**SUBJECT:** R.E. Ginna Nuclear Power Plant  
Docket No. 50-244

**Response to Requests for Additional Information Regarding Topics  
Described by Letter Dated November 3, 2005**

Attachment 3  
Response November 3 Request for Additional Information  
**NON-PROPRIETARY**

Figure 1 – Steam Generator Mass vs. Time – HZP SLB

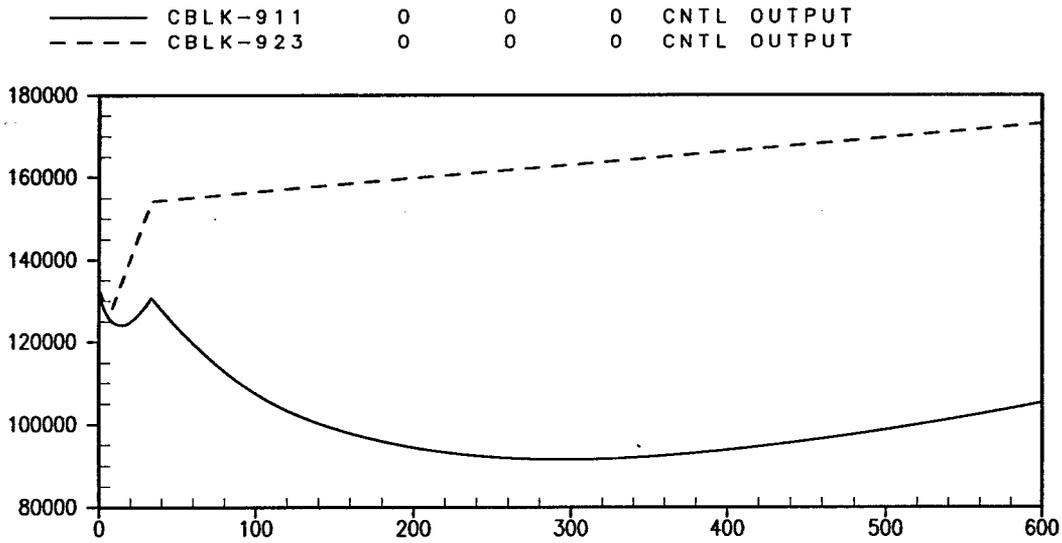
1. Provide a graph of SG mass versus time.
